Access Compliance Report

Public Rights-of-Way

Intersection ID: 10036708	Main Street: S_CLARKSON_ST	Cross Street: N/A	Location: N
ADA ID: 8D92026A7AD7	Ramp Type: BlendTrans1	Initial Pass/Fail: Pass	Overall Compliance: No
Severity Score: 12.75			
Codes/Mitigation Info/Possible Solution		Field Measurements/Component Compliance

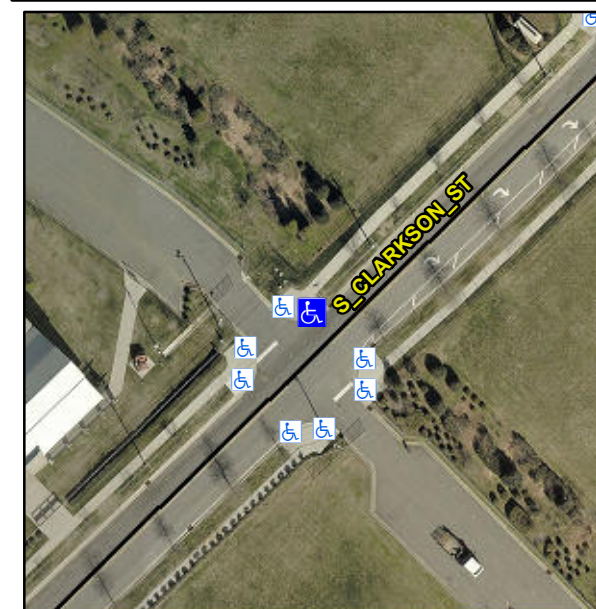
Remove & Replace Detectable Warning System. Remove & Replace Gutter.

R305.2, R302.7.2, R304.5.4
